ENGINE - POWER PLANT - INTRODUCE A NEW FANCASE HARNESS WITH REVISED LENGTH LOOMS -
CATEGORY CODE 7 - MOD.ENG-71-0159

V2500-ENG-71-0159

Location of fan case harnesses
Fig.1

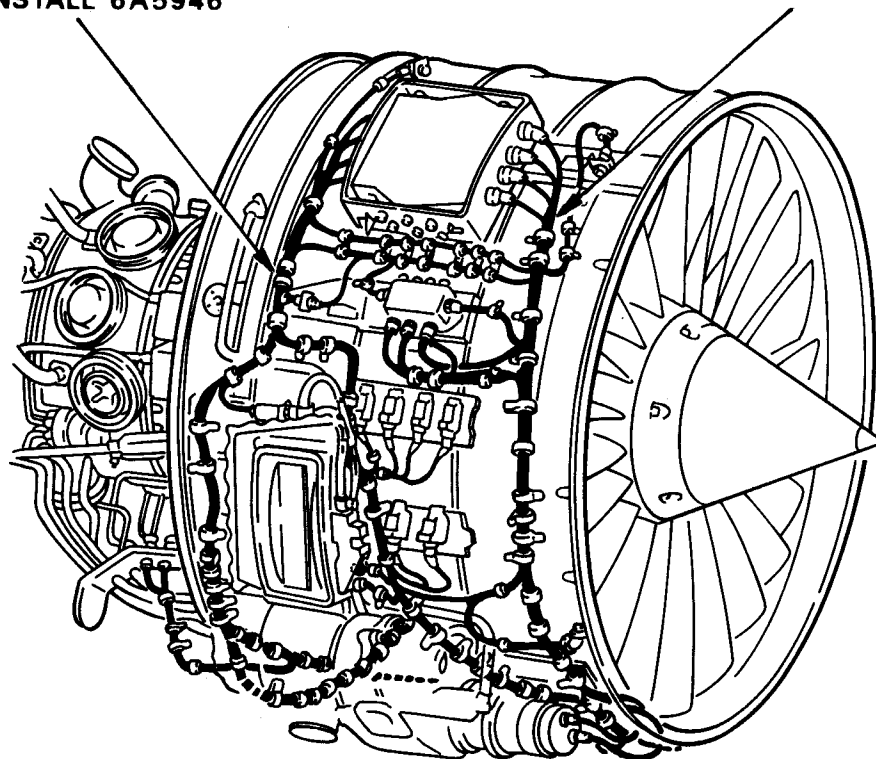
REMOVE 6A5941 LOOM B
AND INSTALL 6A5946

REMOVE 6A5940 LOOM A
AND INSTALL 6A5945

- (1) New 6A5945 harness assembly loom 'A' and new 6A5946 harness assembly loom 'B' are fully interchangeable with in use harness assemblies.
- (2) Install the new 6A5945 harness assembly loom 'A' and new 6A5946 harness assembly loom 'B' by use of approved procedures, Engine Manual, 72-00-32, Installation -04.
